Title **FEZ Feather - Micro**

Title <b>FEZ Feather</b>			501 E Whitcomb Avenue Madison Heights, MI 48071 USA	
Size: A4	Number:	Revision: B		
Date: 7/05/2020		Sheet 2 of 2		
File: C:\GitHub\GHI\FEZ-Feather\FEZ-Feather-Misc.SchDoc

### WiFi

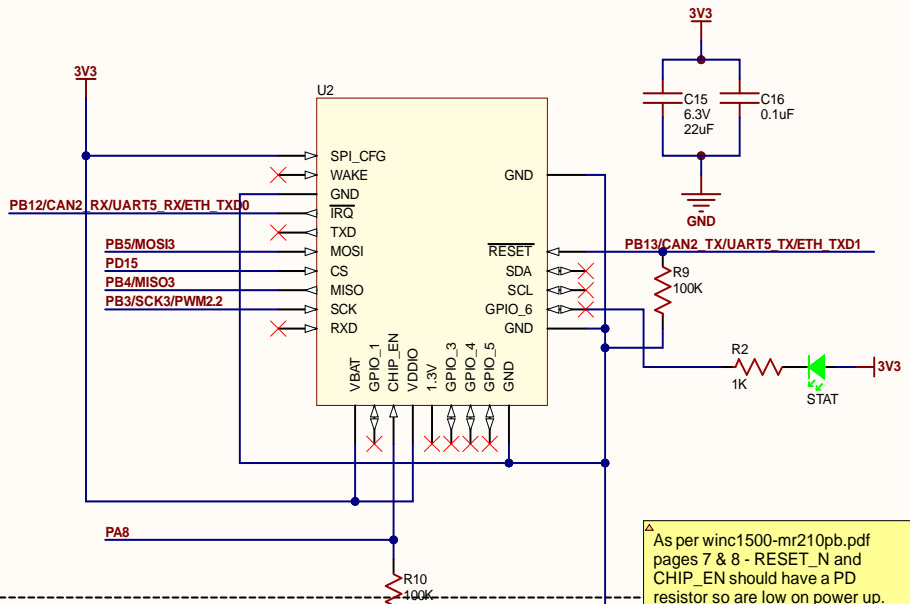
As per winc1500-mr210pb.pdf pages 7 & 8 - RESET\_N and CHIP\_EN should have a PD resistor so are low on power up.

### POWER

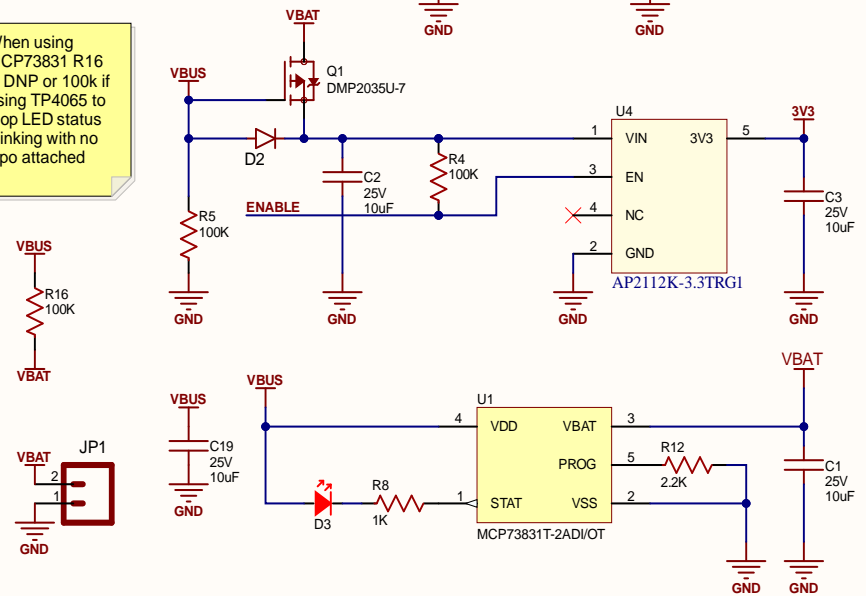
When using MCP73831 R16 is DNP or 100k if using TP4065 to stop LED status blinking with no Lipo attached
